Access Compliance Report

Public Rights-of-Way

(Curb Ramps)

Intersection ID: 29368	Main Street: LUNDY_LN	Cross Street: MOSSY_OAK_LN	Location: S
ADA ID: 2D43971C875E	Ramp Type: Perp	Initial Pass/Fail: Fail	Overall Compliance: No
Severity Score: 10			
Codes/Mitigation Info/Possible Solution		Field Measurements/Component Compliance

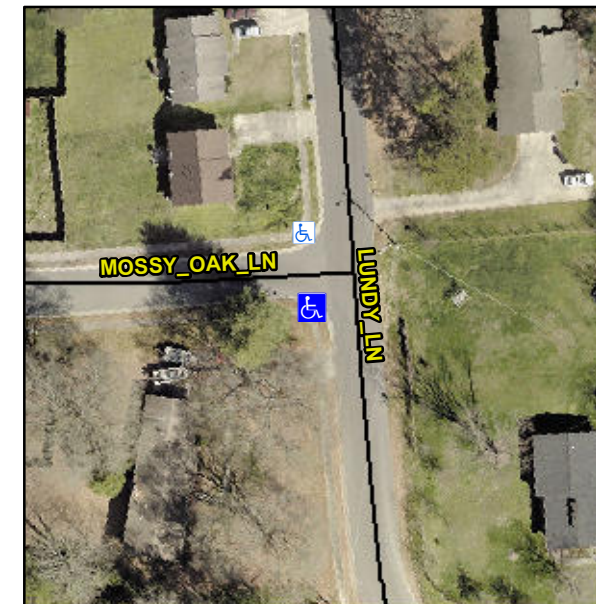
R304.5.1, R304.5.3

Compliance	Description	Data	Compliance	Description	Data
N/A	Ramp Length (in)	48.0	Yes	Ramp Slope (%)	8.0
No	Ramp Width (in)	44.0	No	Ramp XSlope (%)	3.3
N/A	Flare Type LT	N/A	N/A	Flare Type RT	N/A
N/A	Flare Slope LT (%)	N/A	N/A	Flare Slope RT (%)	N/A
N/A	Flare Traversable LT?	N/A	N/A	Flare Traversable RT?	N/A
N/A	Landing Length (in)	N/A	N/A	DWS Provided?	N/A
N/A	Landing Width (in)	N/A	N/A	DWS Contrast?	N/A
N/A	Landing Slope (%)	N/A	N/A	DWS Length (in)	N/A
N/A	Landing X Slope (%)	N/A	N/A	DWS Full Width?	N/A
N/A	Landing Curb? (Y/N)	N/A	N/A	DWS Offset (in)	N/A
N/A	Shared Landing?	N/A			
N/A	Gutter Ponding?	N/A	N/A	Gutter Slope (%)	N/A
N/A	Gutter Lip Ht (in)	N/A	N/A	Gutter X Slope (%)	N/A
N/A	Painted X Walk1?	No	N/A	Painted X Walk2?	N/A
	X Walk 1 Direction	To N		X Walk 2 Direction	N/A
N/A	X Walk 1 Width (in)	N/A	N/A	X Walk 2 Width (in)	N/A
	X Walk 1 Slope (%)	2.6		X Walk 2 Slope (%)	N/A
	X Walk 1 X Slope (%)	3.0		X Walk 2 X Slope (%)	N/A

Remove & Replace Entire Ramp.
